WALL CHECK

*4401 Garrison St, N.W.
Lot 80 or 1501*

Zoning review 1

Board of Zoning Adjustment
District of Columbia
CASE NO. 21374A
EXHIBIT NO. 3

Wall Report for.....SQUARE 1581.....LOT 80.....

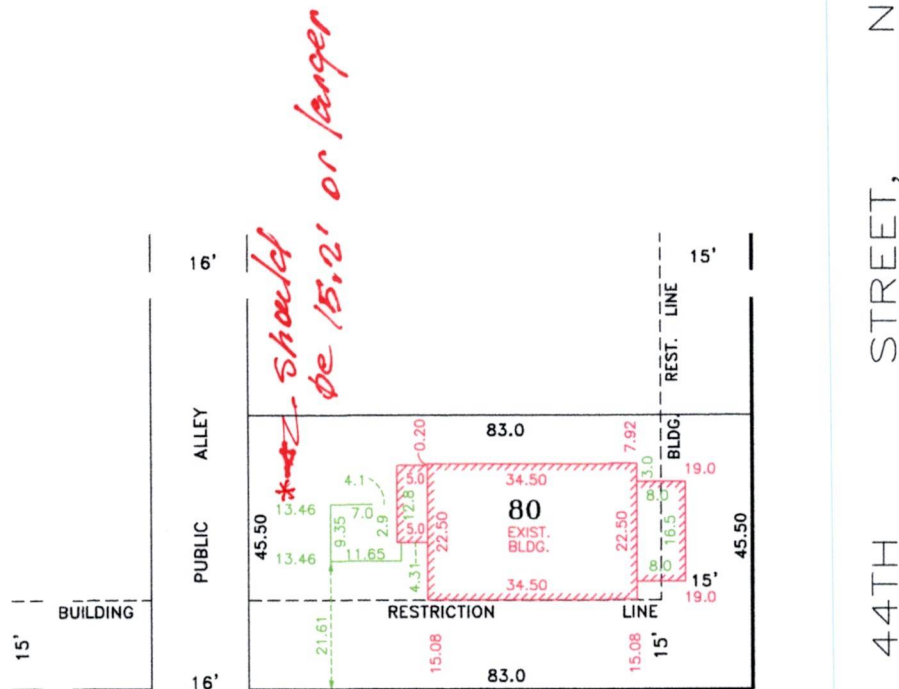
Applicant received relief from the BZA for a 15.2' rear setback, and the built structure provides a 13.46' rear setback which increases,

*Wall check was
REJECTED by Zoning*
